**Re: Engineering Comments – Latimer Lane School Renovations
33 Mountain View Road
Simsbury, Connecticut
SLR #14485.00037.0030**

SLR International Corporation (SLR) is in receipt of a memorandum from you addressed to Thomas Hazel, Assistant Town Planner for the Town of Simsbury dated March 1, 2022, regarding the above-referenced project. We offer the following responses to the comments therein:

UTILITIES SKETCH 1 (COMMENT 10)
LATIMER LANE SCHOOL RENOVATION

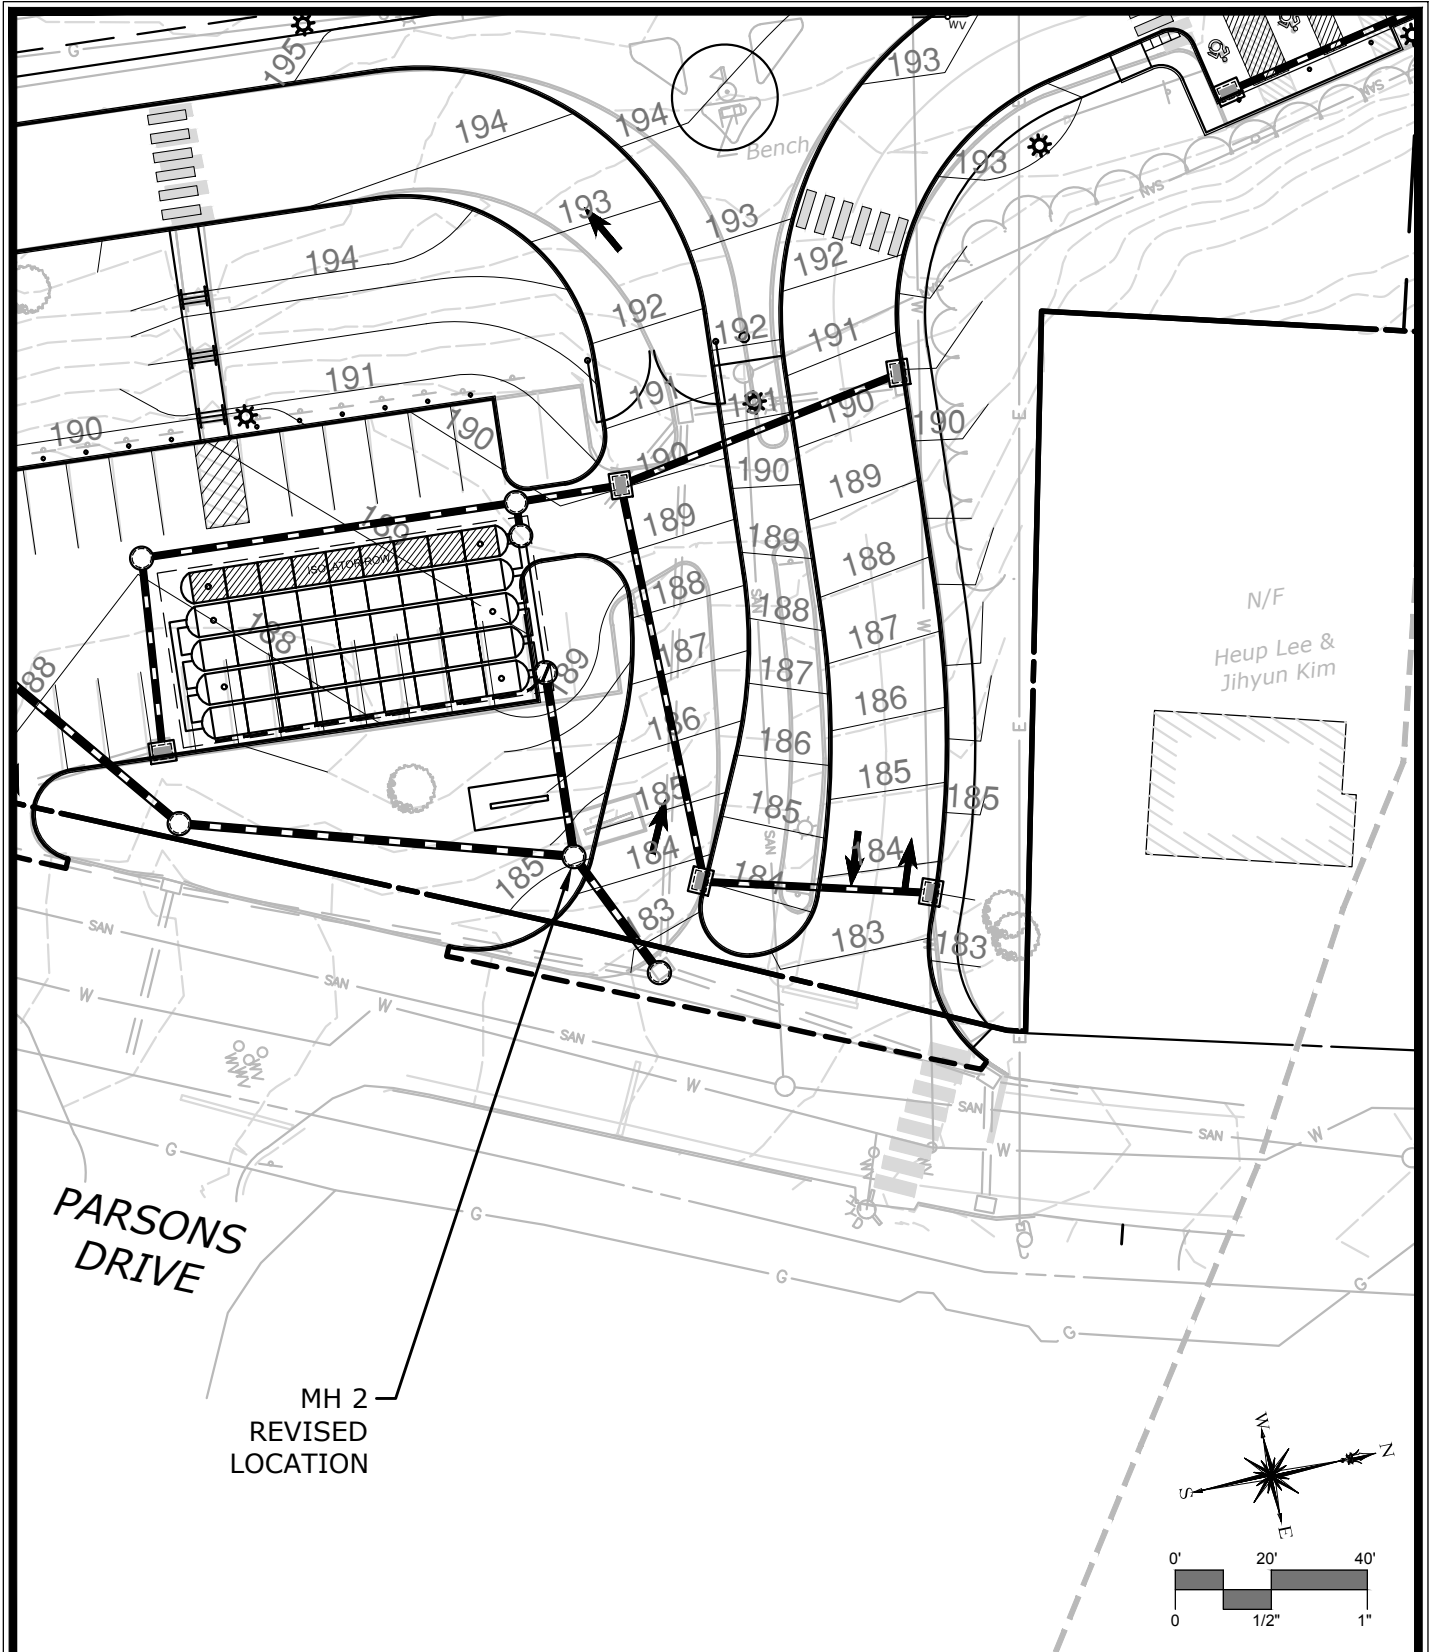
- C10. Relocated proposed manhole structures #1 & #2 in entrance drive to bus drop-off area as proposed location may create future maintenance issues.

MH1 is set to intercept the existing drainage system. Consider relocating MH2 outside of the entrance driveto prevent future maintenance issues.

- R10. MH 2 has been relocated outside of the entrance drive. This change will be reflected on the final plans. See attached.**

UTILITIES SKETCH 2 (COMMENT 12)

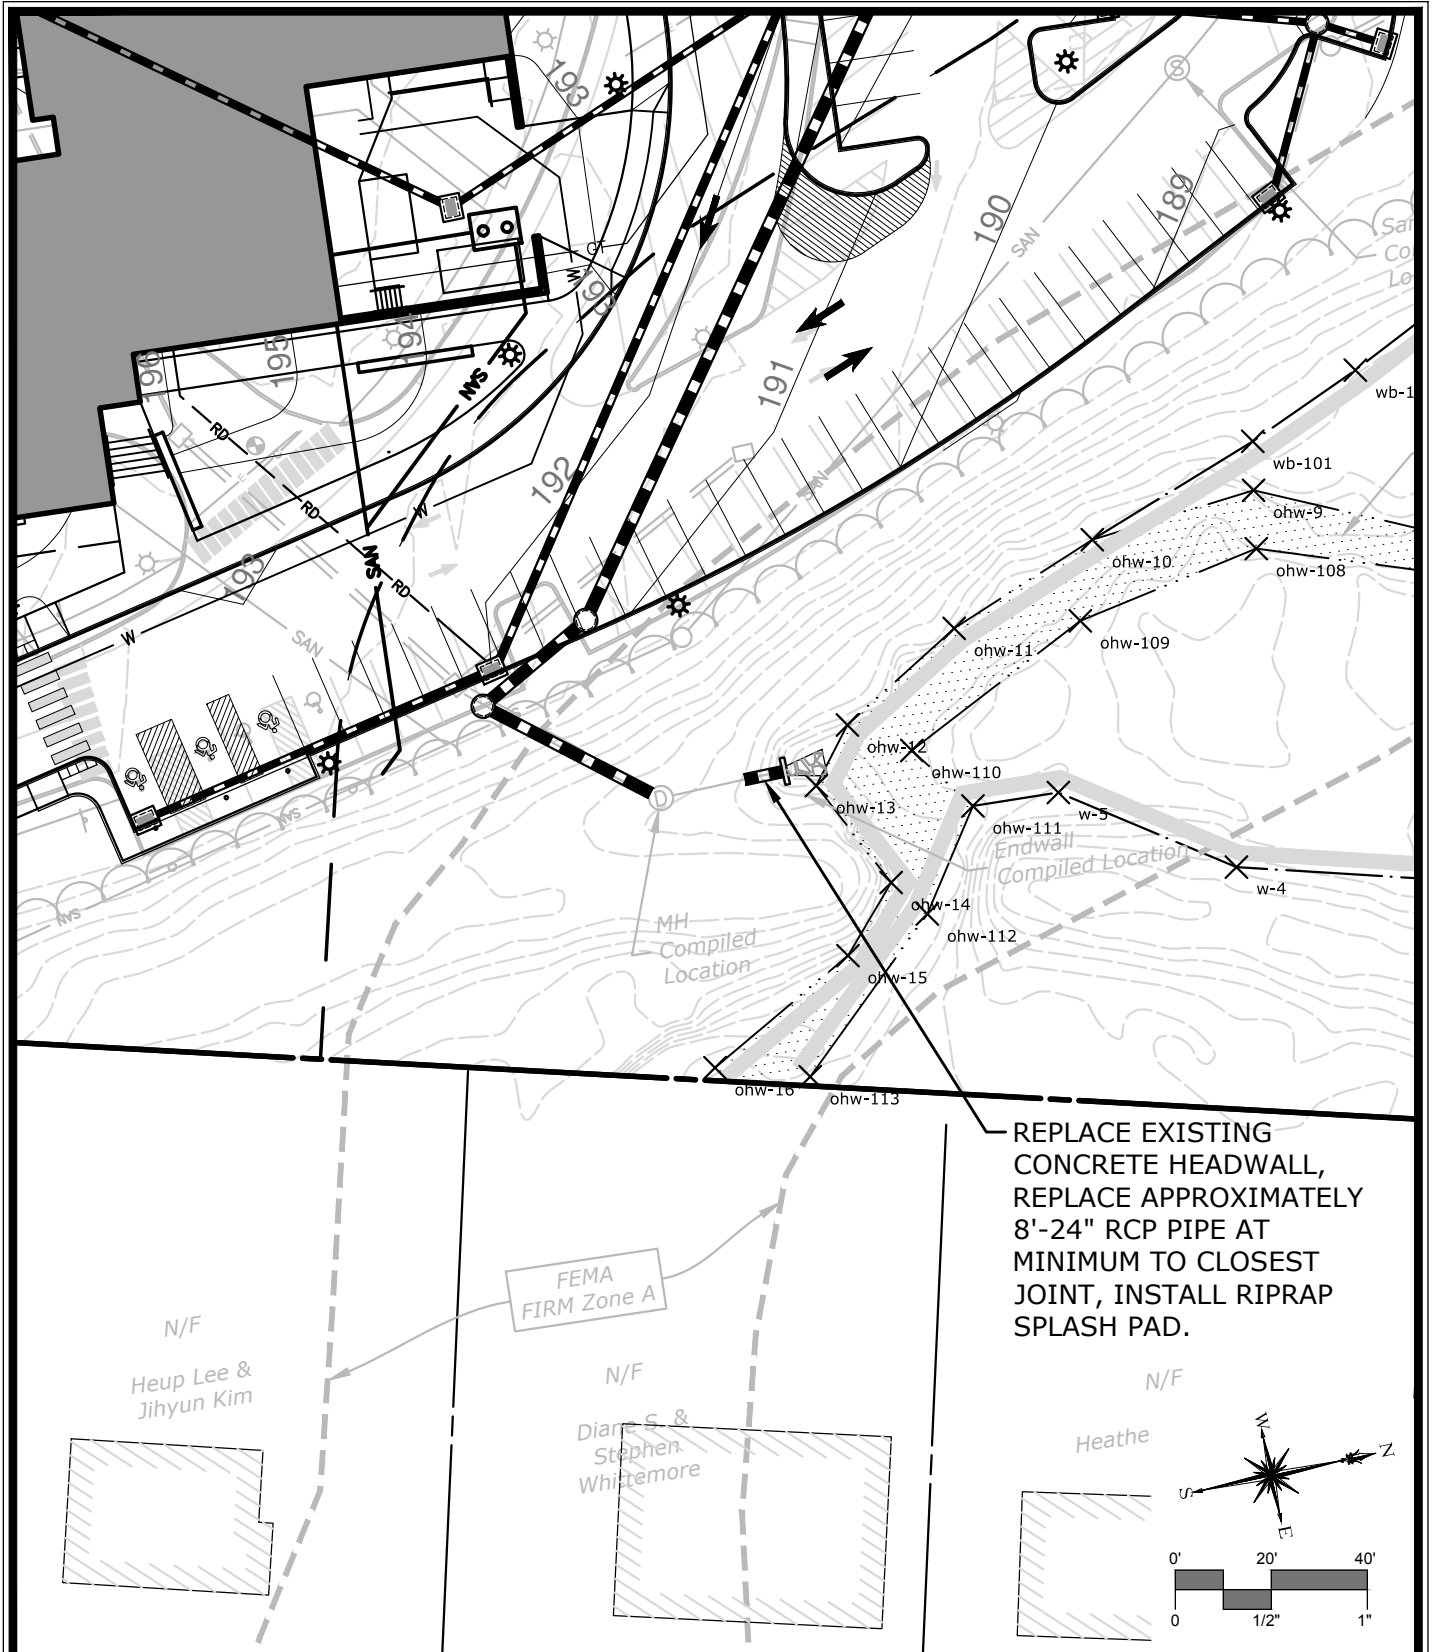
- C12. Provide riprap protection at outlet to stormwater system discharging to watercourse.

This comment has not been adequately addressed. Identify whether riprap protection will be proposed at this discharge location.

- R12. An investigation has shown the headwall and adjacent pipe has settled and is disjointed from the upstream pipe. The existing concrete headwall and pipe will be replaced. A new riprap splash pad will be installed and will be shown on the final plans. See attached.**

CURB RAMP ON RADIUS
 SCALE: N.T.S.

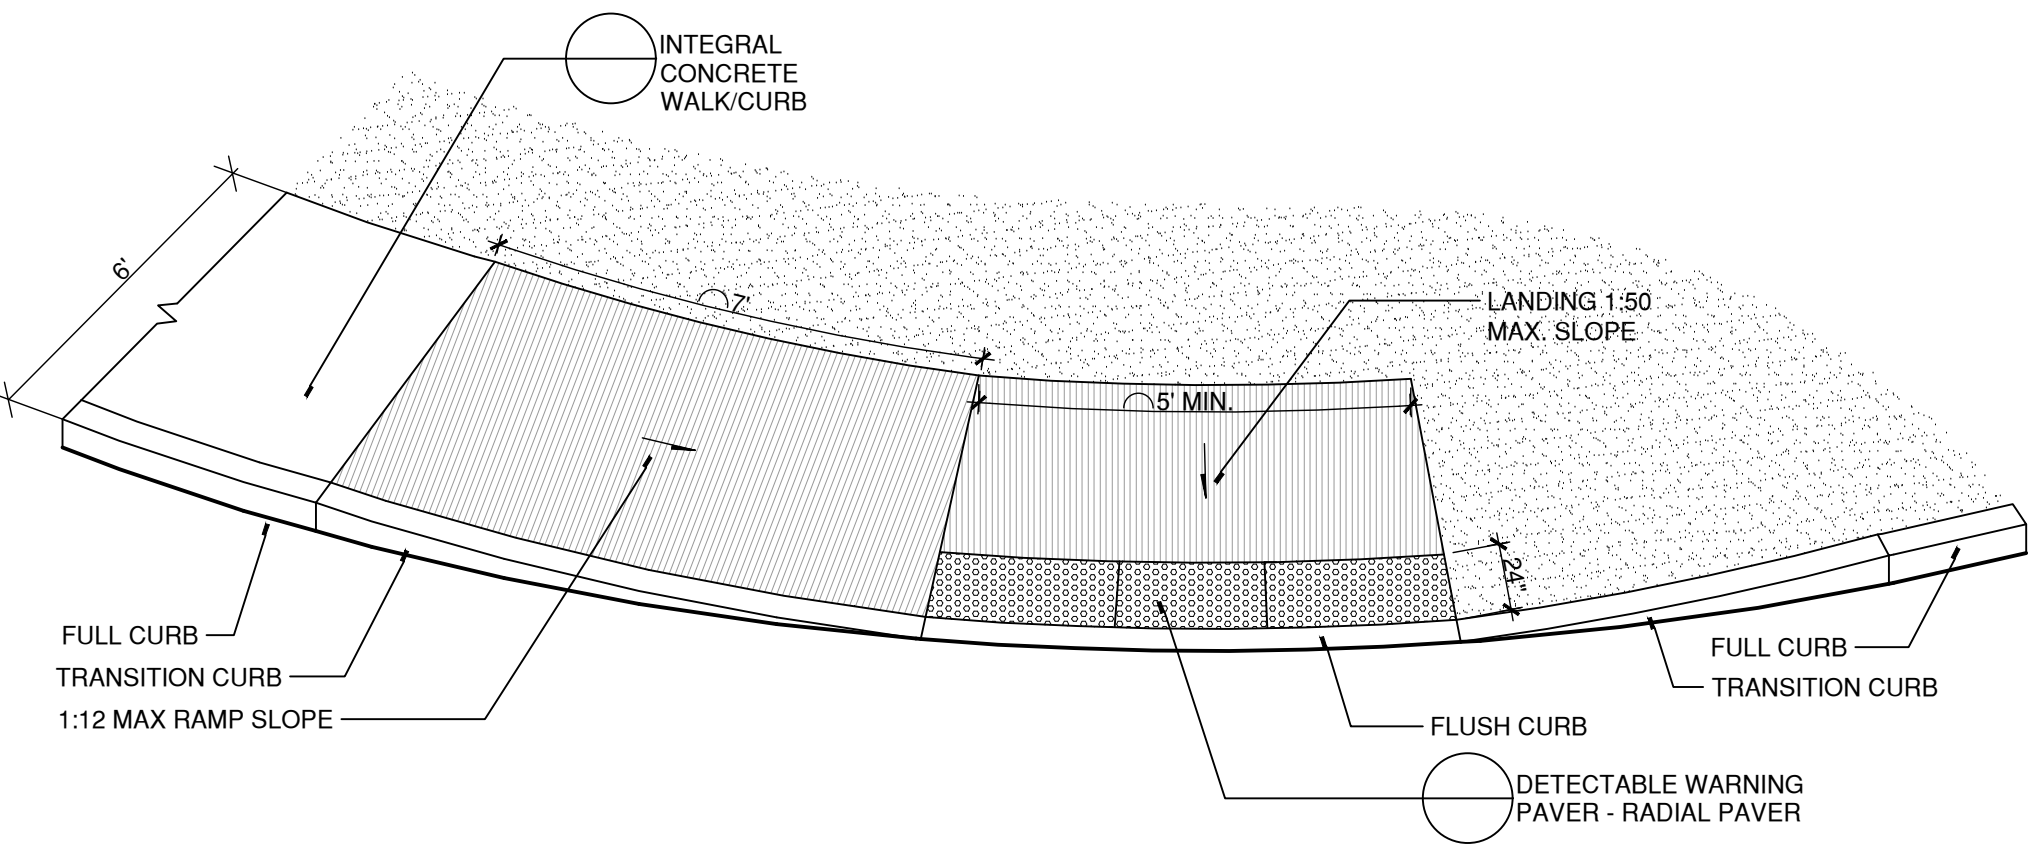
- C13. Provide sidewalk ramps which comply with ADA standards as well as details for them. These details shall include but not be limited to material type, maximum slope requirements and detectible warning pads.

The Ramped Sidewalk Curb Ramp Detail applies to the ramp to the east of the northern proposed addition. A ramp detail is needed for the ramp to the north of the northern proposed addition. Confirm whether a ramp is proposed at the crosswalk to the east of the renovated school or if this will be a crosswalk abutting a curb.

- R13. Additional curb ramp details will be added to the final plans. Please see the attached Ramped Sidewalk Curb Ramp – Type 2 for the curb ramp at the north addition. A curb ramp can be provided at the crosswalk to the east of the school – please see attached Curb Ramp on Radius.**

CROSSWALK PAVEMENT MARKING

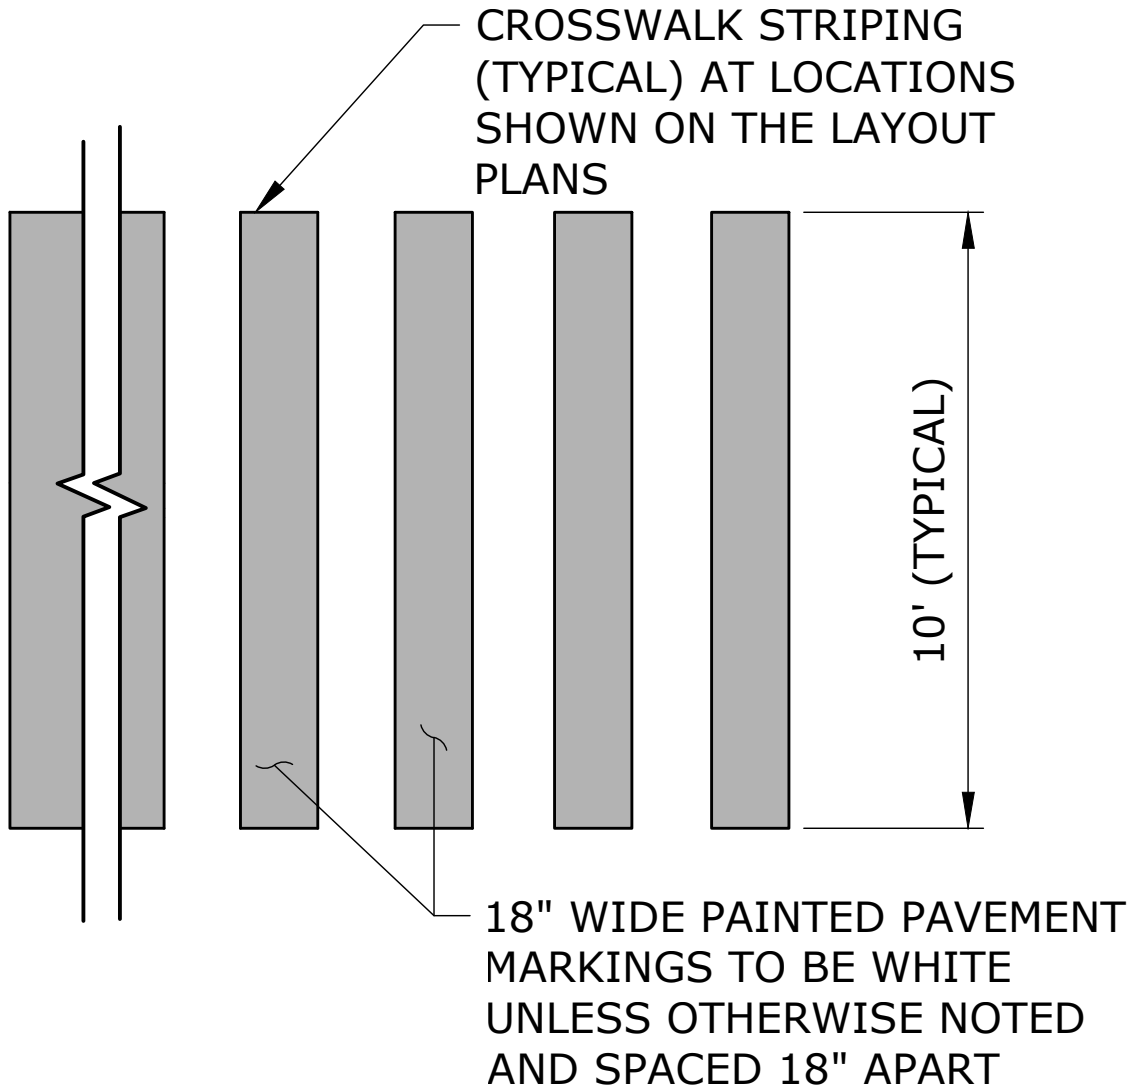
C20. Identify the paint color, width, spacing, etc. of the crosswalks on-site. Provide a detail for the

R20. See enclosed detail that will be included on the final plans.
